LARTIGUE'S LANDING SUBDIVISION,
RESUBDIVISION OF LOTS 2 & 3

APPLICATION NUMBER 8 DATE June 18, 2009

DETAIL SITE PLAN

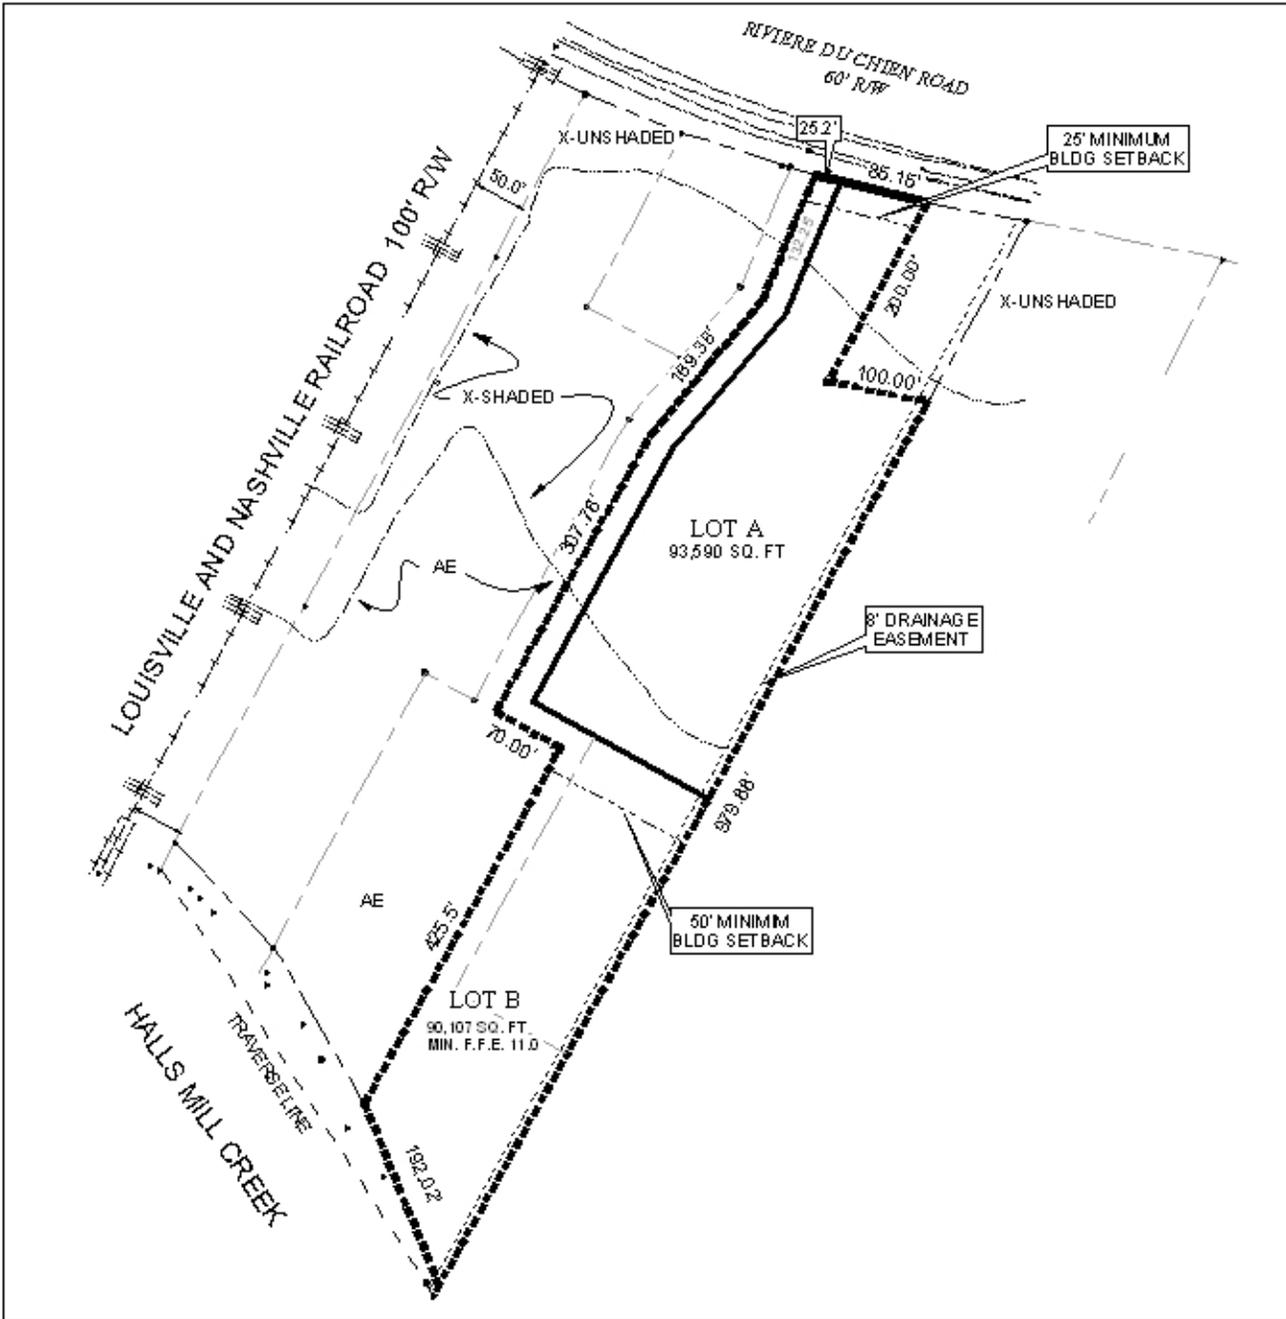
Each lot is labeled on the plat with its size in square feet. The plat should be revised to label each lot with its size in both square feet and acres, or a table should be provided furnishing the same information. As on the original plat, a note should be added to the final plat stating that there shall be no future resubdivision to create additional lots unless a City standard street is to be dedicated and constructed to provide access.

- 1) placement of a note on the final plat stating that both lots shall share a common curb cut to Riviere du Chien Road, with the size, location, and design to be approved by Traffic Engineering and conform to AASHTO standards;

- 2) addition of a signature block to the final plat for the City Traffic Engineer to sign;
- 3) illustration of the 25' minimum building setback line along Riviere du Chien Road for Lot A, and a 50" minimum building setback line for Lot B, as measured from the South line of Lot A;

- 4) revision of the plat to label each lot with its size in both square feet and acres, or the provision of a table on the plat furnishing the same information;

- 5) placement of a note on the final plat stating that there shall be no future resubdivision to create additional lots unless a City standard street is to be dedicated and constructed to provide access;
